Subject: <u>Bid No. 8319-W5, Window Replacement – Worcester East Middle School / WPS</u>

**ADDENDUM NO. 1**

Window and Door Replacement Worcester, East Middle School 420 Grafton Street, Worcester, MA 01604

### ADDENDUM NO. 01 November 08, 2024

SYMBOLS, ABBREVIATIONS, **GENERAL NOTES & CODE SUMMARY**

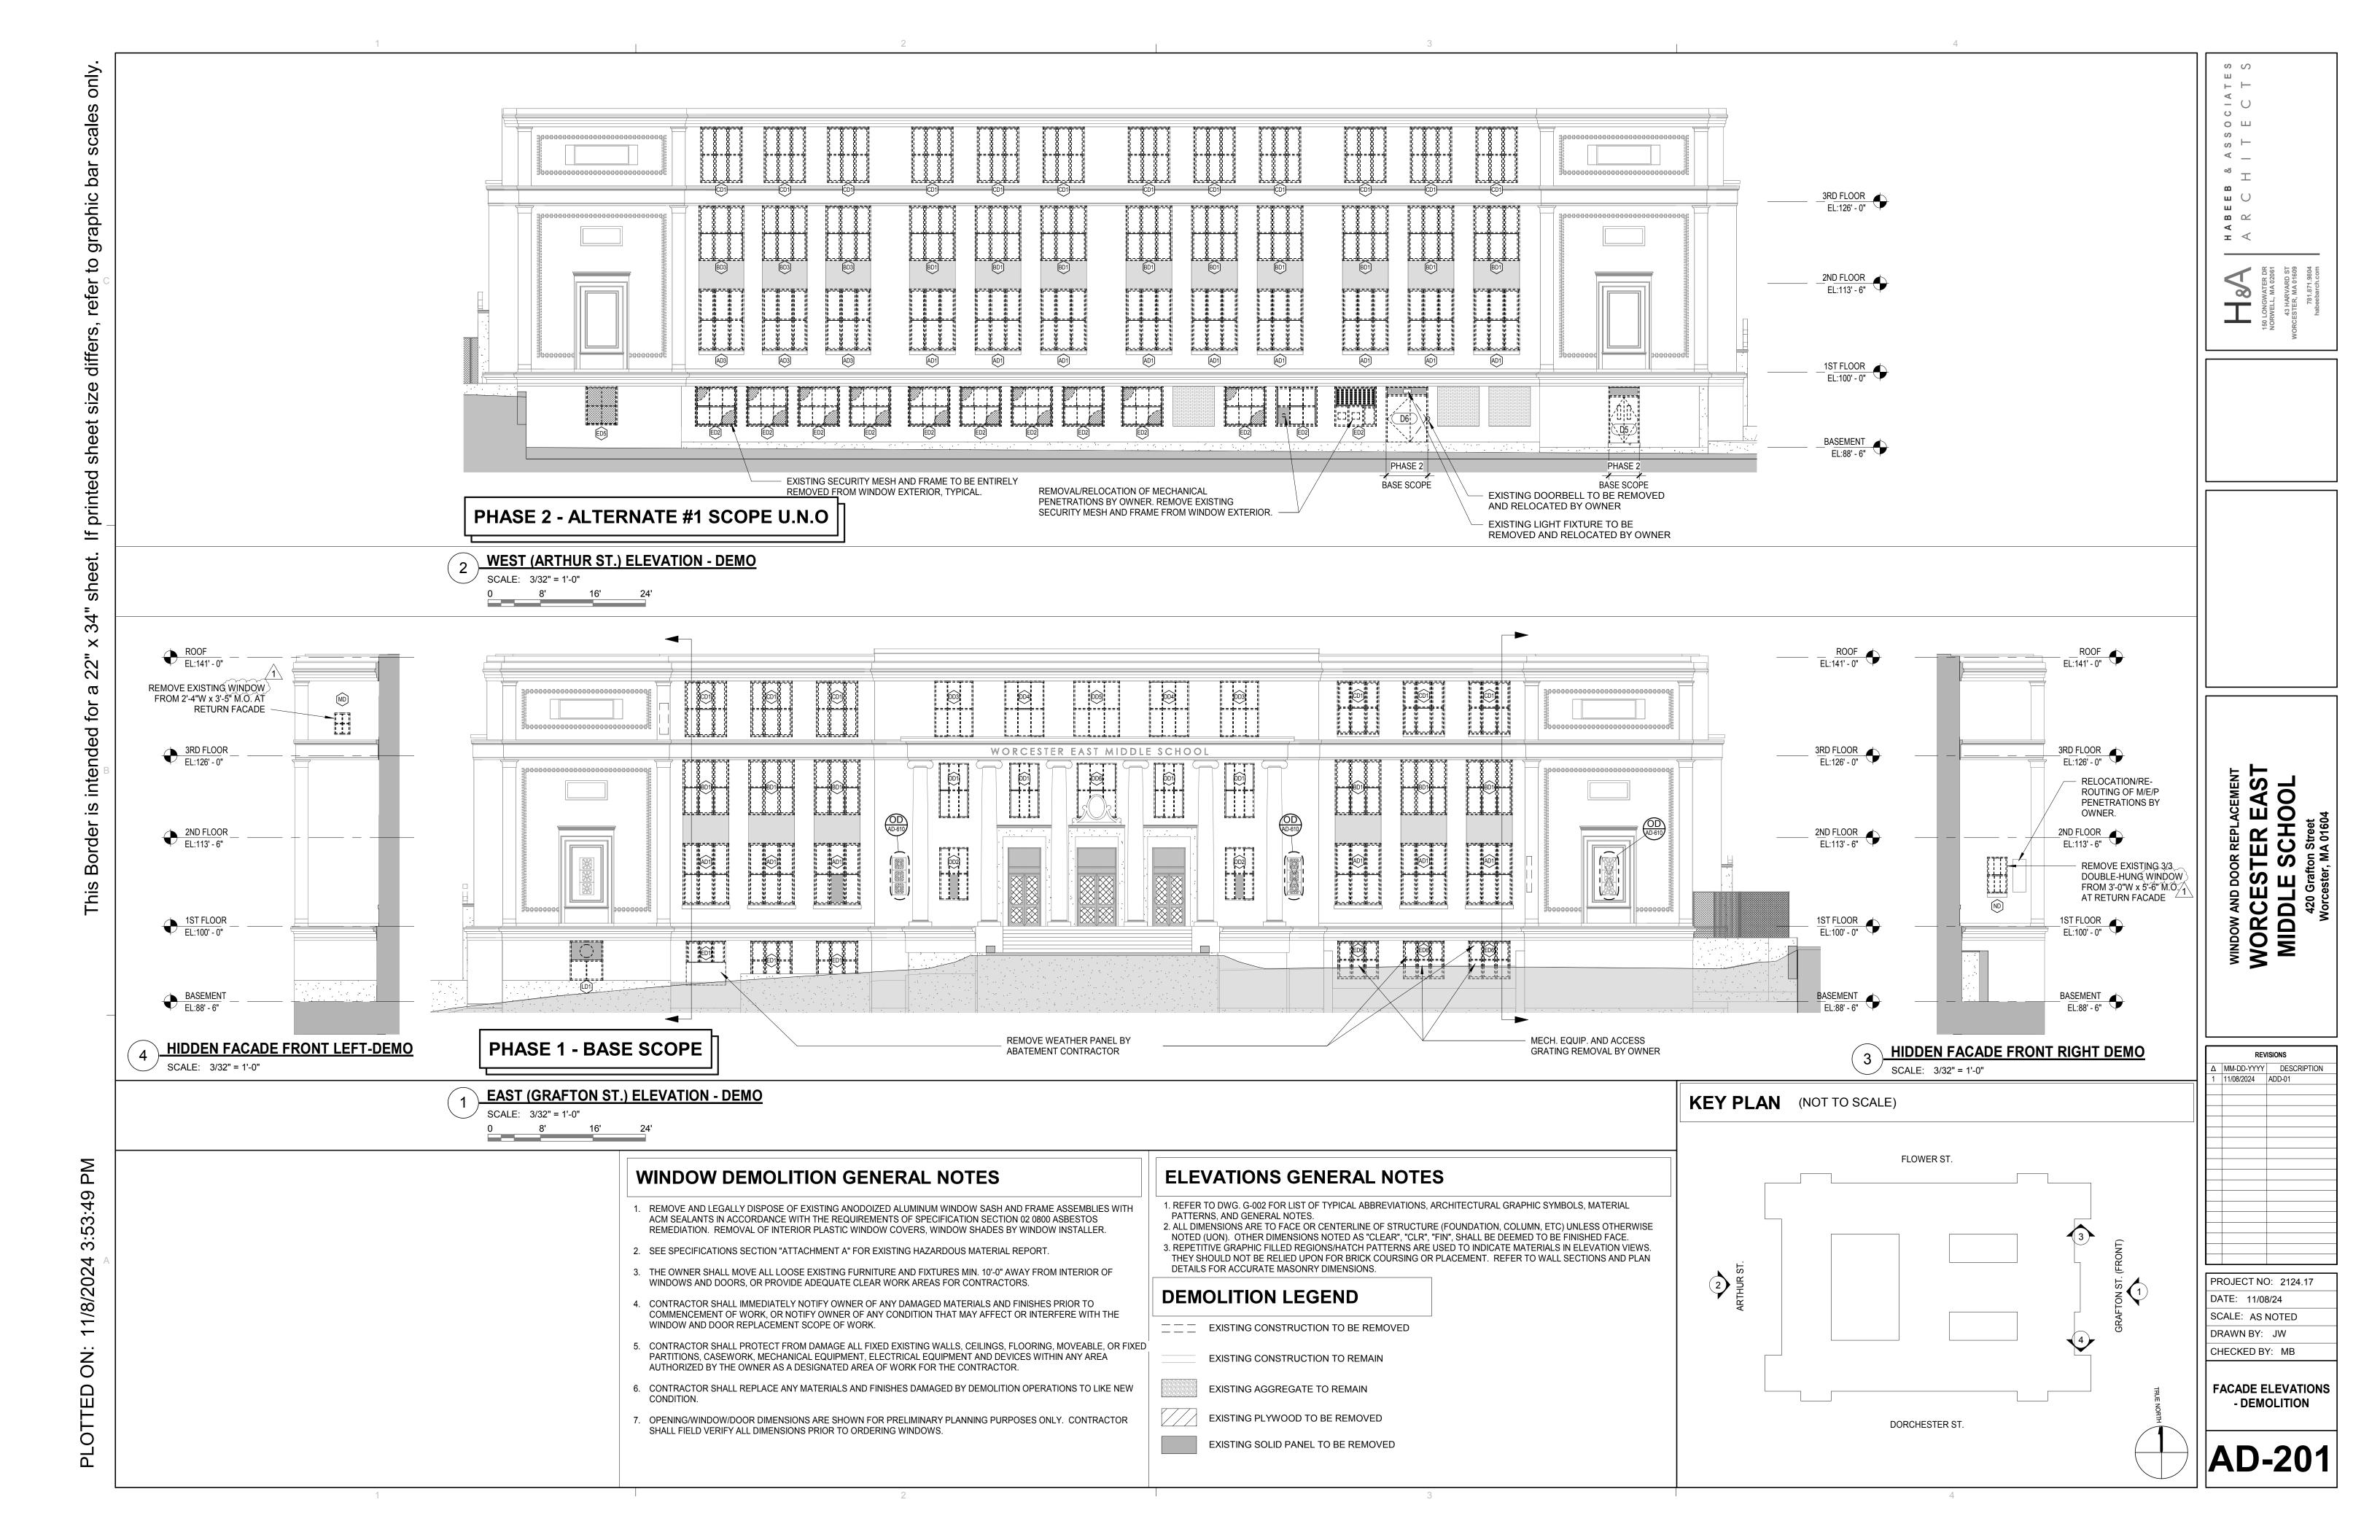
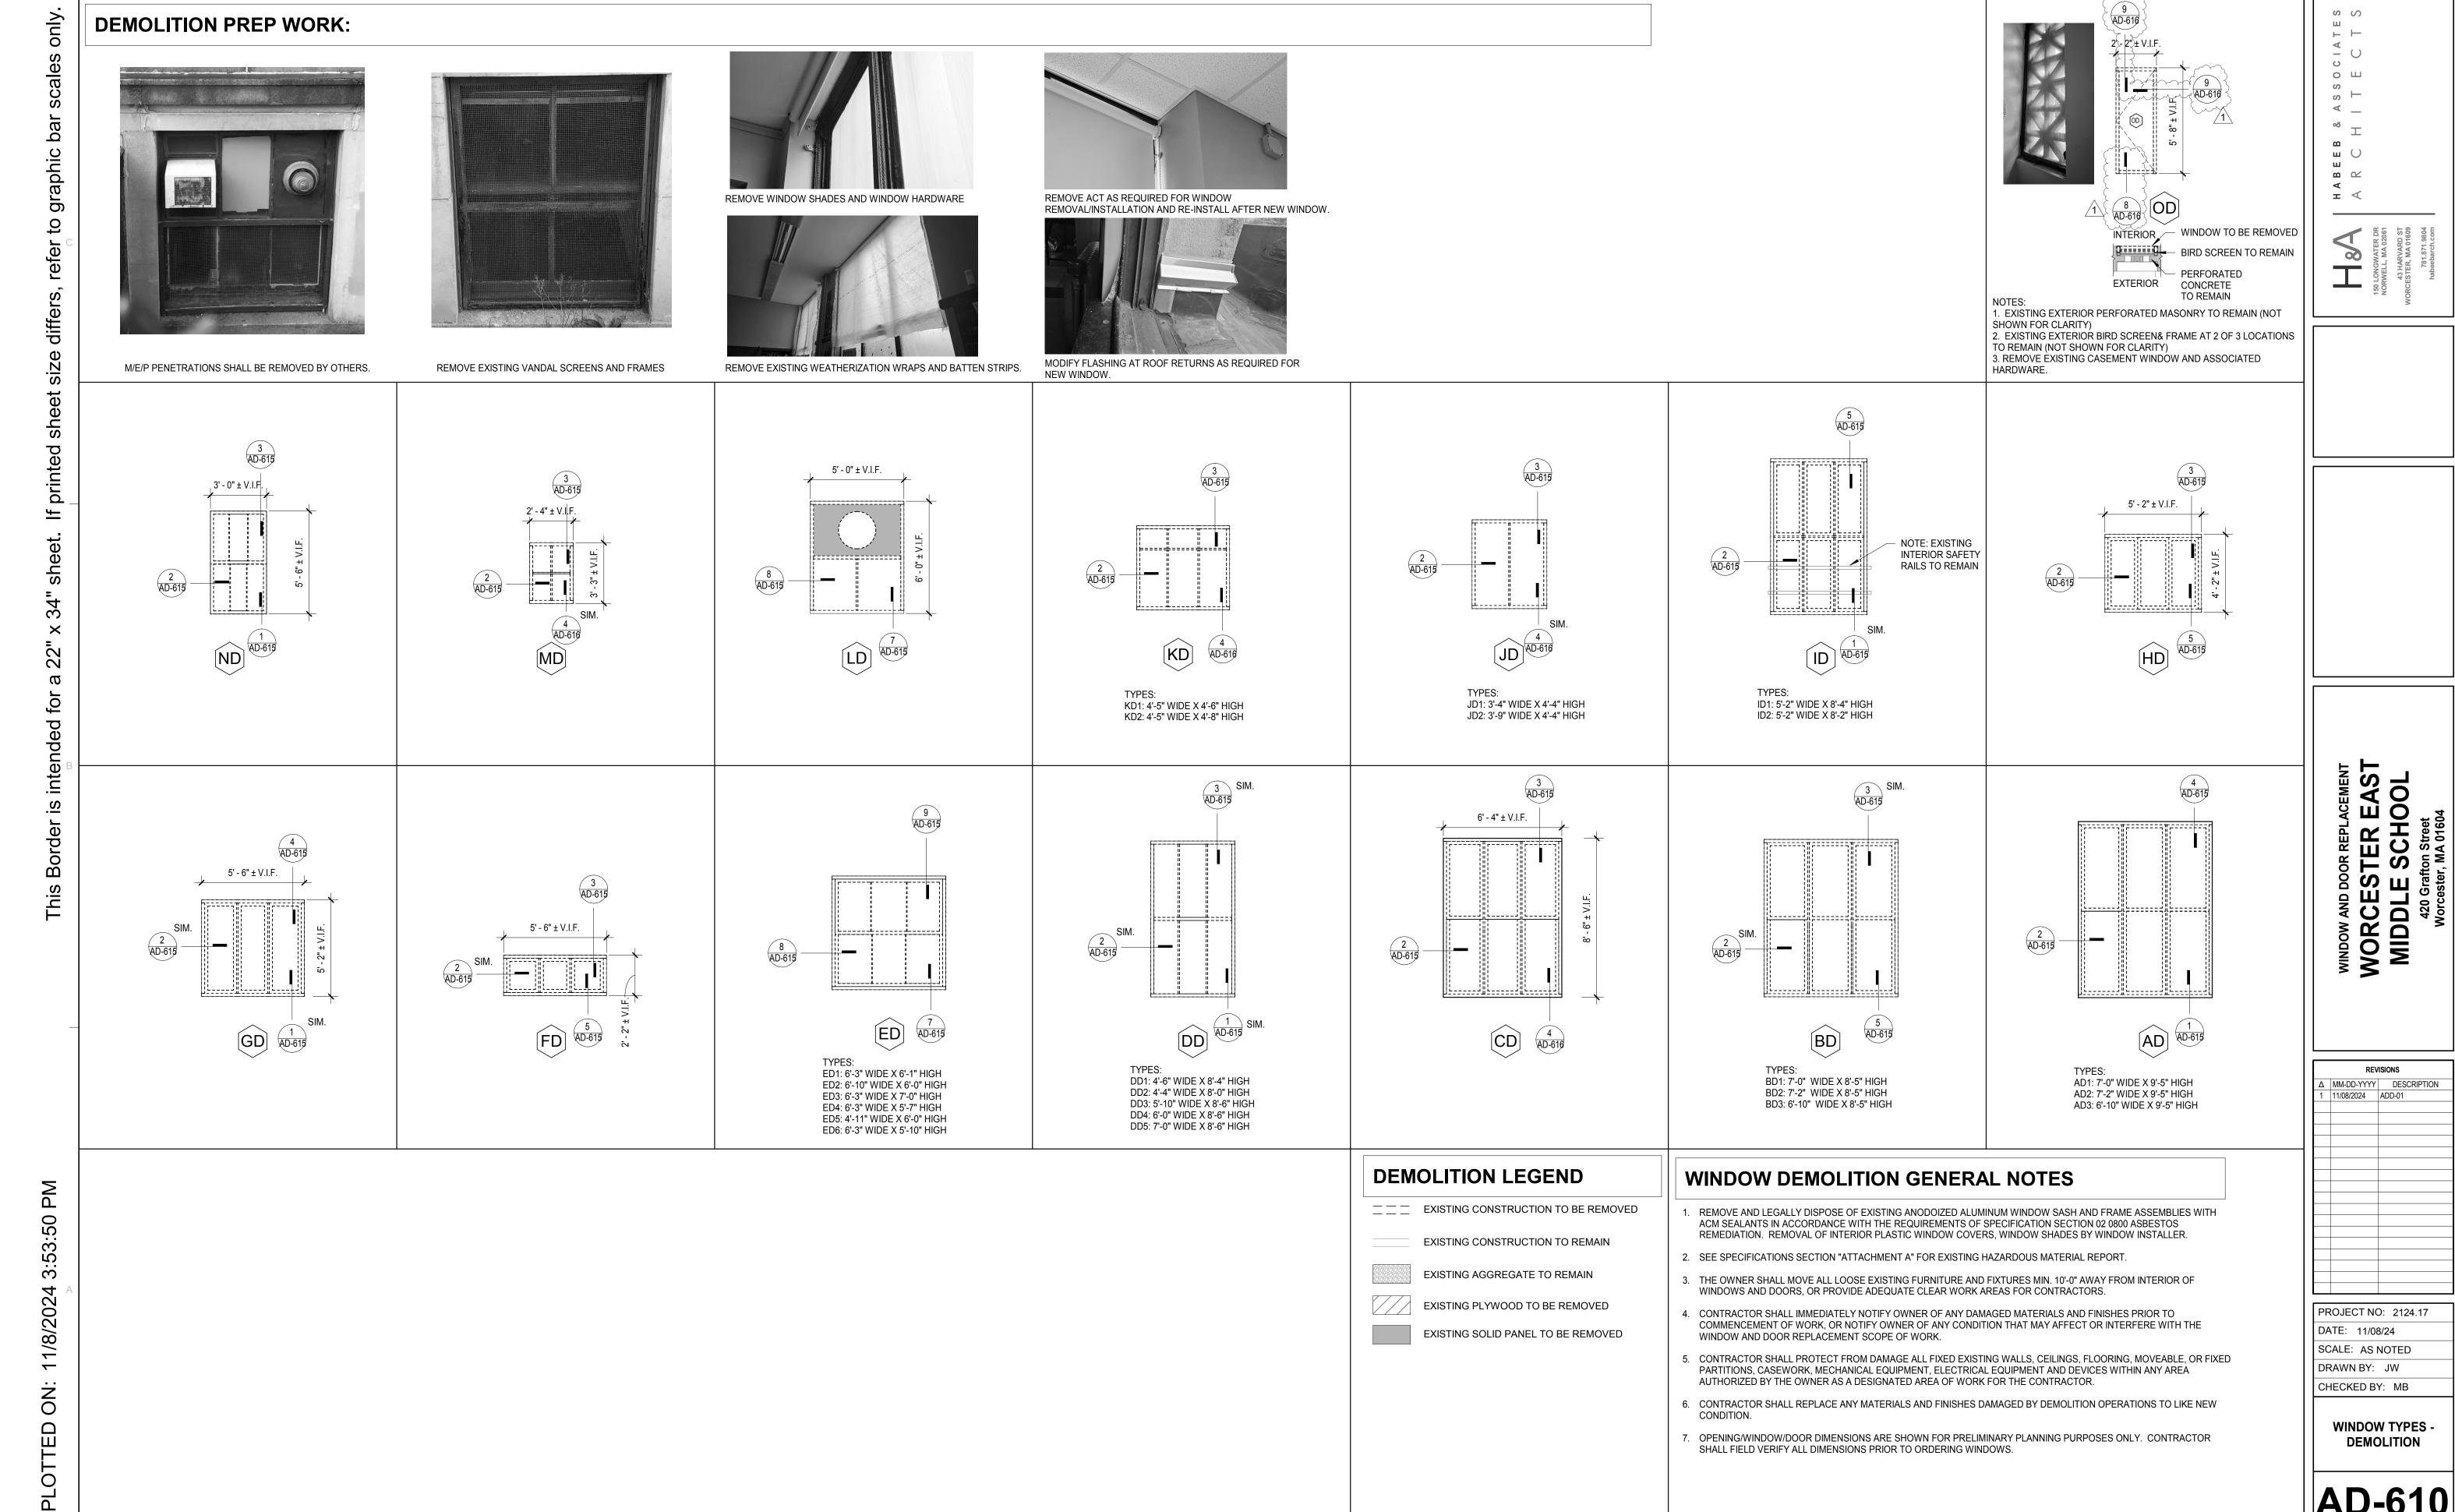
- 1. Sheet G-002:
  - a. Removed the Exception from Section C401.2.1
  - b. Removed mentions of residential energy code under the stretch energy code section.

RESPONSE: Please see the code study on the drawings for 'Fixed Fenestration' on sheet G-002.
